Access Compliance Report

Public Rights-of-Way

(Curb Ramps)

Intersection ID: 10025447	Main Street: E_INDEPENDENCE_BV	Cross Street: N/A	Location: S
ADA ID: 0DF0488E8624	Ramp Type: Perp	Initial Pass/Fail: Fail	Overall Compliance: No
		Severity Score: 12.5

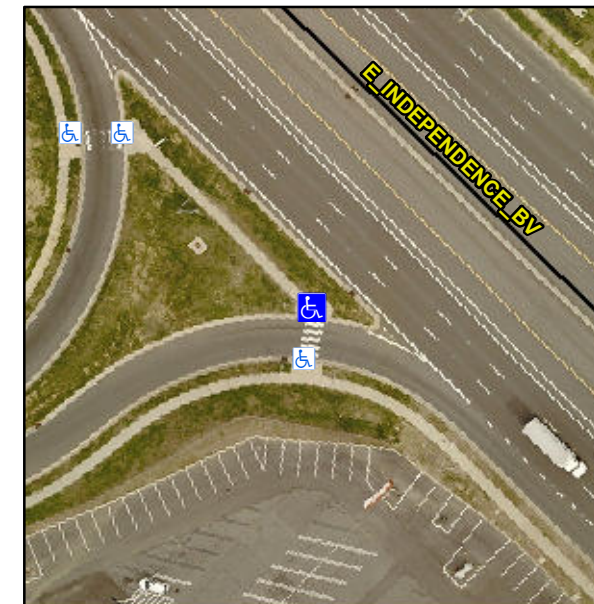
Not Found, R304.2.2

Compliance	Description	Data	Compliance	Description	Data
N/A	Ramp Length (in)	65.0	No	Ramp Slope (%)	9.0
Yes	Ramp Width (in)	59.0	Yes	Ramp XSlope (%)	0.3
N/A	Flare Type LT	N/A	N/A	Flare Type RT	N/A
N/A	Flare Slope LT (%)	N/A	N/A	Flare Slope RT (%)	N/A
N/A	Flare Traversable LT?	N/A	N/A	Flare Traversable RT?	N/A
N/A	Landing Length (in)	N/A	N/A	DWS Provided?	N/A
N/A	Landing Width (in)	N/A	N/A	DWS Contrast?	N/A
N/A	Landing Slope (%)	N/A	N/A	DWS Length (in)	N/A
N/A	Landing X Slope (%)	N/A	N/A	DWS Full Width?	N/A
N/A	Landing Curb? (Y/N)	N/A	N/A	DWS Offset (in)	N/A
N/A	Shared Landing?	N/A			
N/A	Gutter Ponding?	N/A	N/A	Gutter Slope (%)	N/A
N/A	Gutter Lip Ht (in)	N/A	N/A	Gutter X Slope (%)	N/A
N/A	Painted X Walk1?	Yes	N/A	Painted X Walk2?	N/A
	X Walk 1 Direction	To S		X Walk 2 Direction	N/A
N/A	X Walk 1 Width (in)	120.0	N/A	X Walk 2 Width (in)	N/A
	X Walk 1 Slope (%)	6.6		X Walk 2 Slope (%)	N/A
	X Walk 1 X Slope (%)	0.2		X Walk 2 X Slope (%)	N/A

Remove & Replace Entire Ramp.
